NTD-NRC-94-4291  
DCP/NRC0204  
Docket No.: STN-52-003

SUBJECT: WESTINGHOUSE RESPONSES TO NRC REQUESTS FOR ADDITIONAL  
INFORMATION ON THE AP600

NTD-NRC-94-4291  
ATTACHMENT A  
AP600 RAI RESPONSES  
SUBMITTED SEPTEMBER 2, 1994

Figure 220.8-1  
Stress-Strain Curve

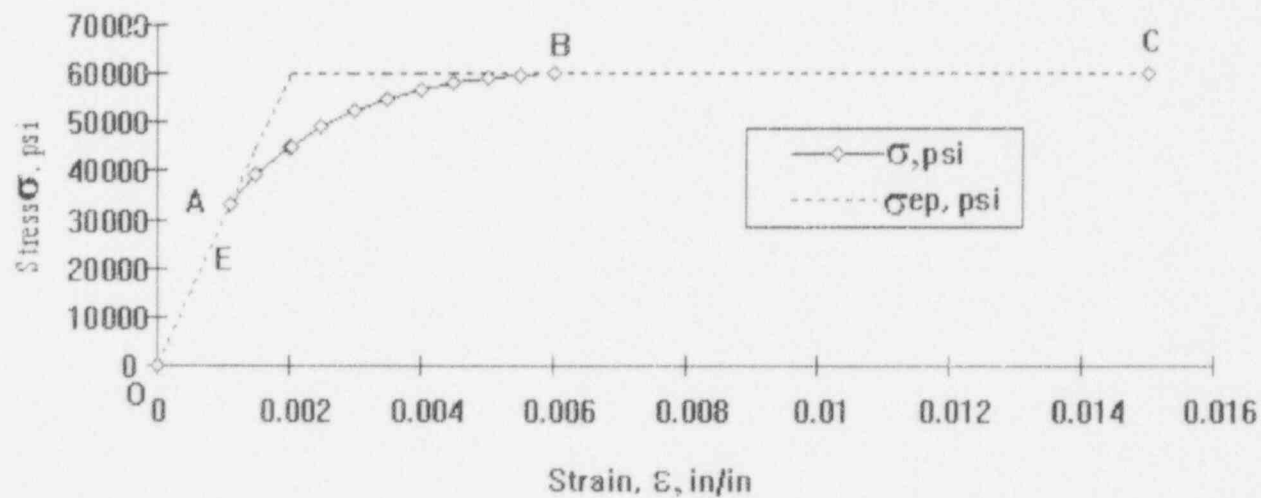
Residual stresses are known to reduce buckling capacity. Describe how residual stresses were incorporated into the analysis (Section 3.8.2.4.2.2).

An additional BOSOR-5 analysis using the model described in Figure 220.6-1 and stress-strain curves given in Figure 220.8-1 was performed. The stress-strain curve 'OABC' was used for the segments representing the knuckle region where circumferential stresses are compressive and meridional stresses are tensile due to internal pressure. This curve is suggested to account for the effects of residual stresses on buckling of cylindrical shells due to axial compression and/or external pressure (Reference 220.8-2). For other segments where both the stresses are tensile, bi-linear elasto-perfectly plastic stress-strain curve was used. The point 'A' was selected at 0.00112 in/in ( $\approx 0.55$  times the yield strain,  $\epsilon_y$ ,  $\epsilon_y = \text{yield strength, } \sigma_y / \text{modulus of elasticity, } E$ ), whereas the point 'B' was at 0.006 in/in (about three times  $\epsilon_y$ ).

The point "A" was selected on the basis of ASME Code Case N-284. The nature of results would indicate that the selection of point "B" will not have any significant impact on the overall conclusions. The equation for the curve "AB" was used as  $\sigma = E\epsilon + K(\epsilon - 0.00112)^n$ , where constants "K" and "n" were determined from the conditions  $\sigma = \sigma_y$  and  $d\sigma/d\epsilon = 0$  at "B", respectively. This analysis concluded that there was no potential buckling due to internal pressure. The reason for this was the development of plastic (softer) region over a larger meridional length. The failure mode was an axisymmetric plastic collapse resulting from excessive vertical displacements at the pole. The pressure-maximum displacement curve is given in Figure 220.8-2. Therefore, the values reported in SSAR are considered to be appropriate.
